## 6-1– 12

### Proposed Change as Submitted

**Fig. 608.3.3**  
**Grab Bars in ~~Alternate Roll-in-Type~~ Combination Showers**

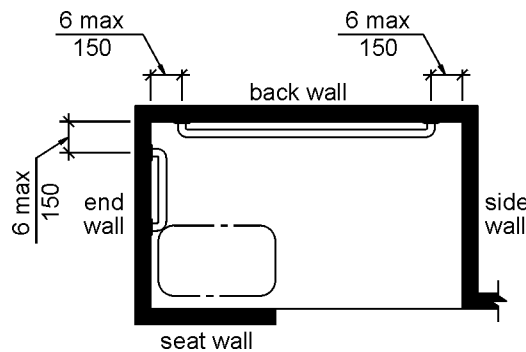
**608.3.3 ~~Alternate Roll-in-Type~~ Combination Showers.** In ~~alternate roll-in type combination~~ combination showers, grab bars shall be provided on the back wall and the end wall adjacent to the seat. Grab bars shall not be provided above the seat. Grab bars shall be 6 inches (150 mm) maximum from the adjacent wall.

**Committee Reason:** The proposal combines scoping with design. Scoping is not appropriate within the design standard. It would establish a conflict with the 2010 ADA. It implies 'technical infeasibility' applies to the whole room, which is not the intent of the Standard.

Fig. 608.4.3  
 Alternate Roll-in-Type Combination Shower Control and Handshower Location

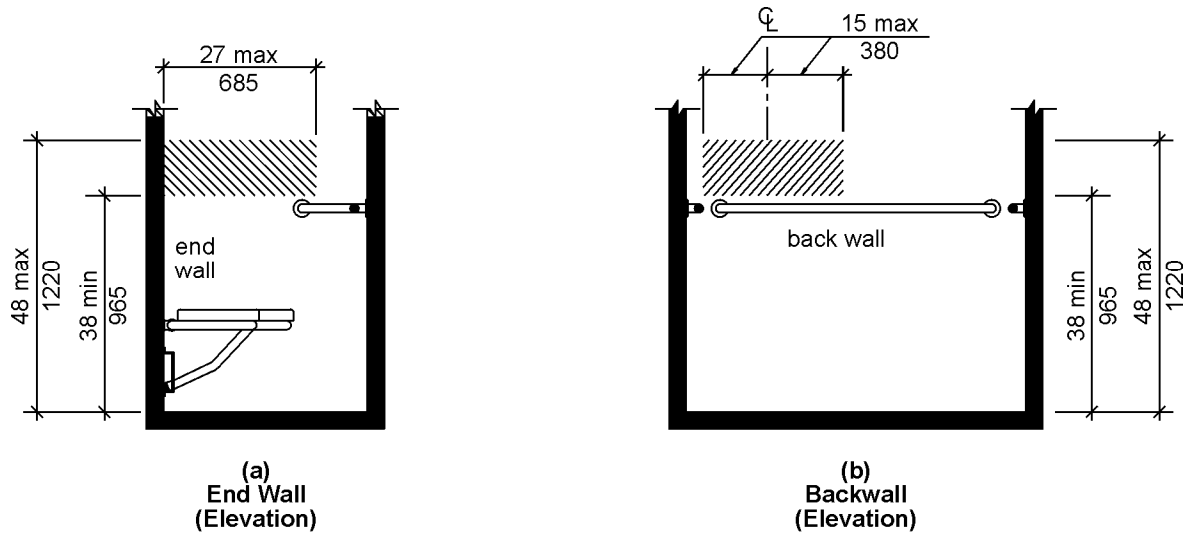
**608.4.3 ~~Alternate Roll-in~~ Combination Showers.** In ~~alternate roll-in combination~~ combination showers, the controls and hand shower shall be located 38 inches (965 mm) minimum and 48 inches (1220 mm) maximum above the shower floor. In ~~alternate roll-in combination~~ combination showers with controls and hand shower located on the end wall adjacent to the seat, the controls and hand shower shall be 27 inches (685 mm) maximum from the seat wall. In ~~alternate roll-in combination~~ combination showers with the controls and hand shower located on the back wall opposite the seat, the controls and hand shower shall be located within 15 inches (380 mm), left or right, of the centerline of the seat.

**6-62– 12**  
**608.4.3, Figure 608.4.3**

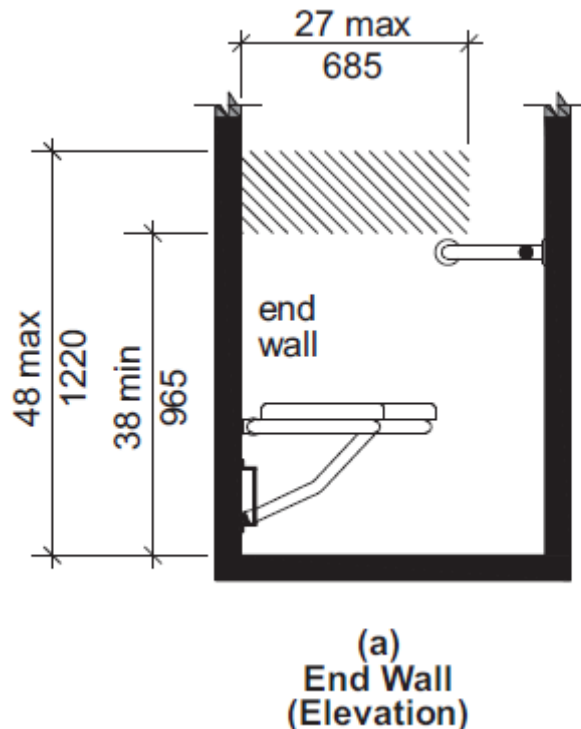
**Revise Figure 608.4.3 as follows:**

**Fig. 608.4.4**  
**Alternate Roll-In Shower**  
**Compartment for Elder Use**  
**Control and Hand Shower Location**

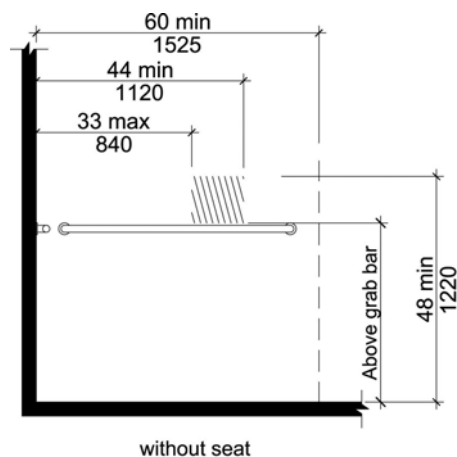
**608.4.4 Alternate Roll-In Type Shower Compartments for Elder Use.** The controls and hand shower provided in a roll-in type shower compartment for elder use shall be located on the back wall above the grab bar, 48 inches (1220 mm) maximum above the shower floor and 16 inches (405 mm) minimum and 44 inches (1120 mm) maximum 33 inches (840 mm) from the side wall.

**Reason:** Provides location for assistance in bathing. See , also White Paper, dated April 22, 2012

**6-68– 12**  
**610.2, Figure 610.2, 610.3**

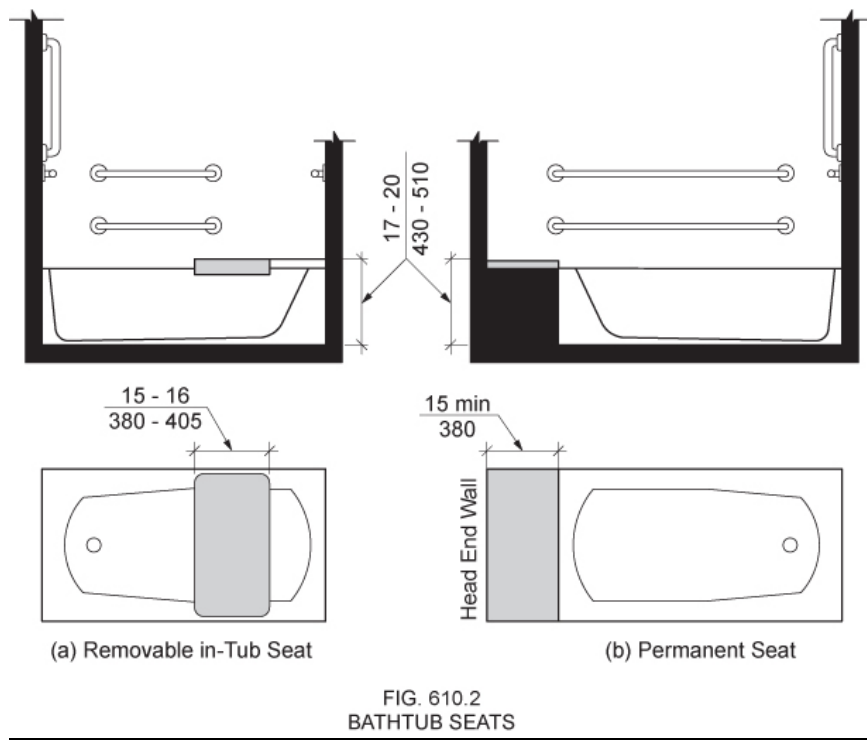
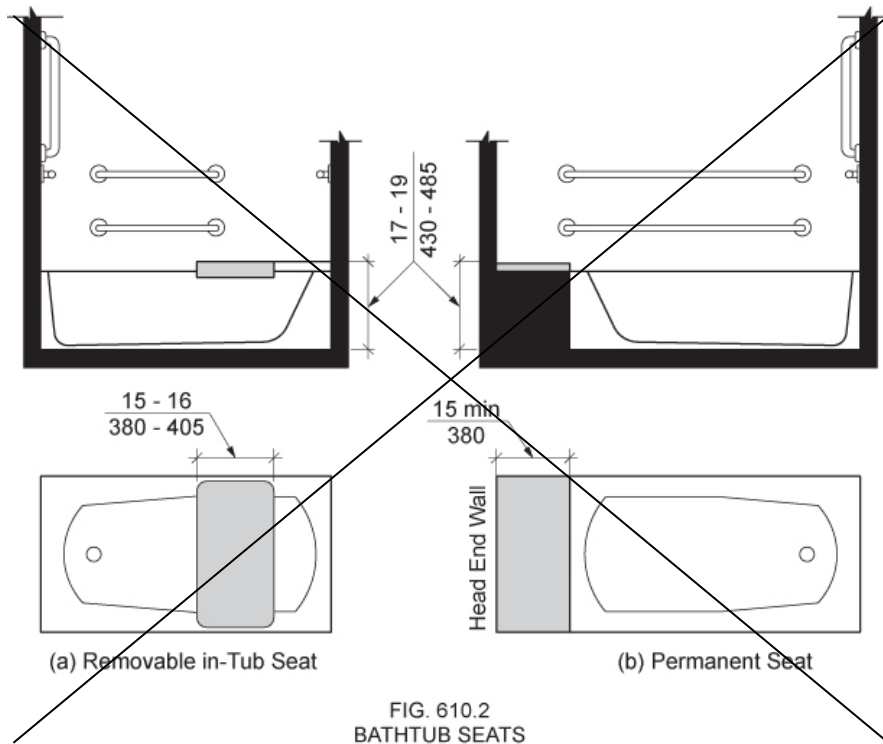
NOTE: This change necessitates a change to Fig. 610.2 to ensure consistency. Thus, the proposed revised figure has been attached, along with the existing figure for comparison purposes.
